UNITED STATES PATENT AND TRADEMARK OFFICE

APPLICATION NO.	FILING DATE	FIRST NAMED INVENTOR	ATTORNEY DOCKET NO.	CONFIRMATION NO.
10/630,598	07/29/2003	Dominik J. Schmidt	015114-049120US	1638

Office Action Summary

DETAILED ACTION

FIG. 1

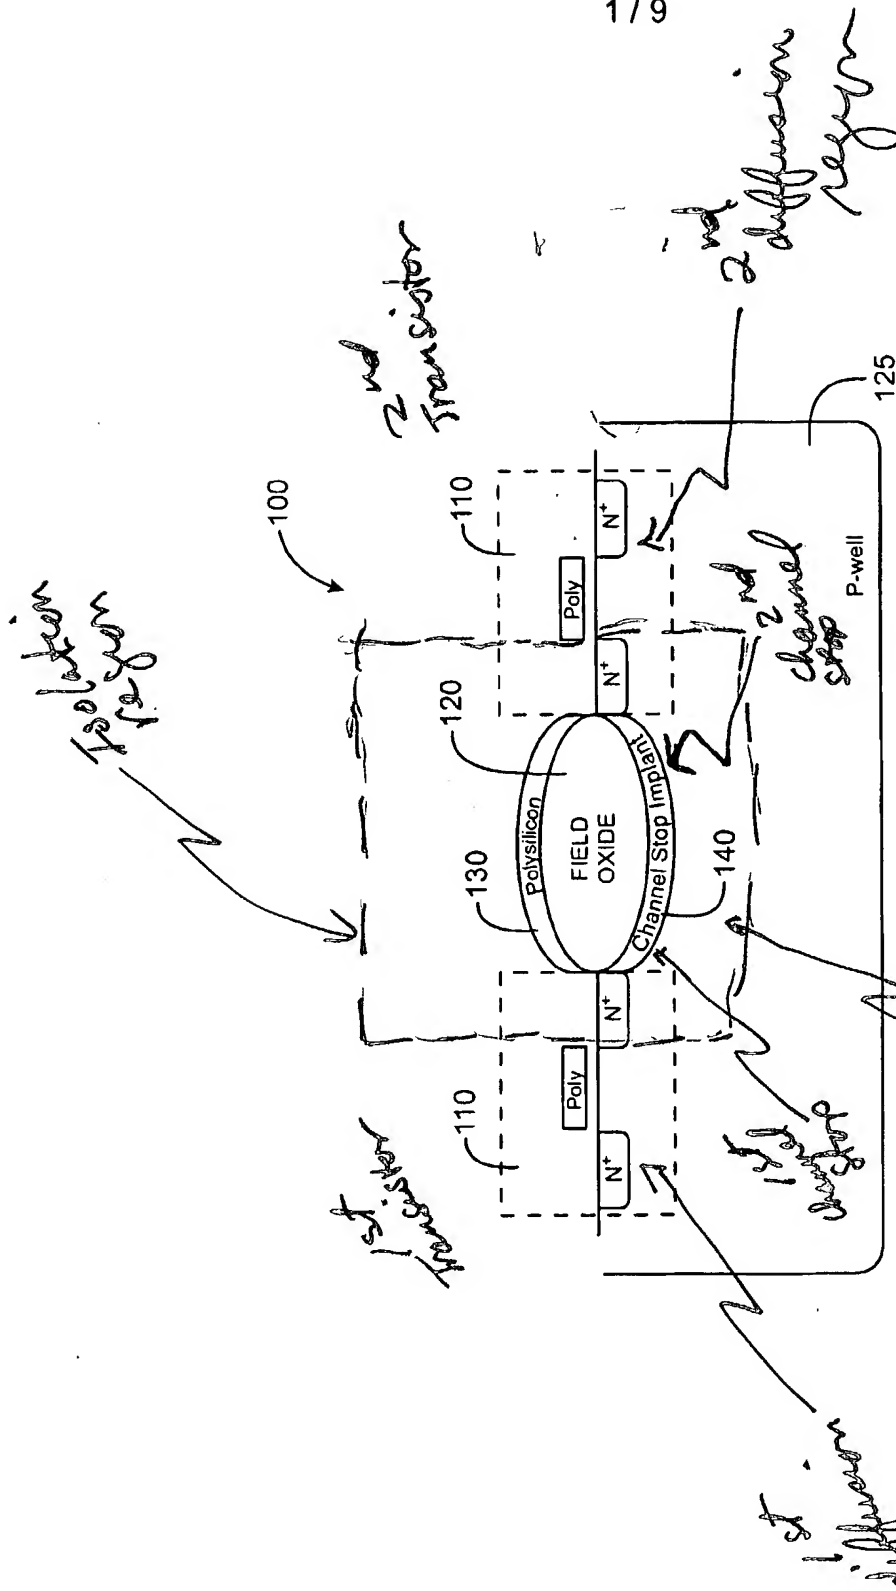
4. Claims 1-5, 7-8, 15-17, 19-20 are rejected under 35 U.S.C. 102(a) as being anticipated by Admitted Prior Art (APA), fig. 1 and specification, pages 1-2.

APA teaches the method of making an IC having the steps of providing a first diffusion region with a source/drain region of a first transistor 110; providing a second diffusion region with a source/drain region of a second transistor 110; providing an isolation region between the first and second diffusion regions, and selectively implanting a first channel stop implant region 140 and a second channel stop implant region 140 in the isolation region, the first channel stop implant region separate from the second channel stop implant region, as claimed in claims 1 and 15. See fig. 1.

As to claims 2, 16, the first channel stop implant region and the second channel stop implant region define at least a portion of an isolation conductive path 130, 140 between the first diffusion region and the second diffusion region. See fig. 1.

As to claim 5, the method further comprising a third diffusion region, wherein the first channel stop implant region and the second channel stop implant region form at least a part of an isolation conductive path between the first diffusion regions the second diffusion region, and the third diffusion region. See fig. 1.

As to claims 7,19, the method further comprising providing a field oxide region 120 over the isolation region. See fig. 1.

As to claims 8, 20, the method further comprising providing a gate 130 over the field oxide region 120, wherein when a threshold voltage is applied to the gate, current flows in the isolation conductive path 130, 140. See fig. 1 and specification, page 2, lines 10-18.
